FCC Class II Permissive Change Application Letter

Applicant's complete, legal business name: Dongguan Beijia Electronic Technology Co., Ltd

FCCID Number and Date of Original Grant: 2AZUG-BJ602 2021-6-8

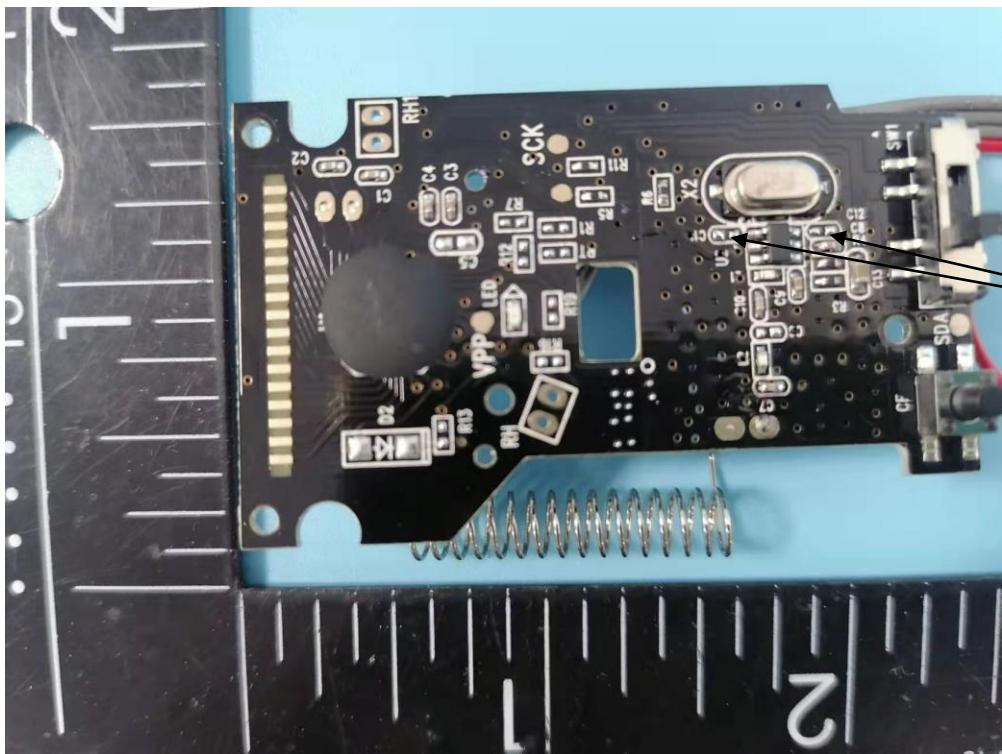
Cancel C5 and C8(The position number of the new board is C11 and C12),
MCU model change to 8NP043
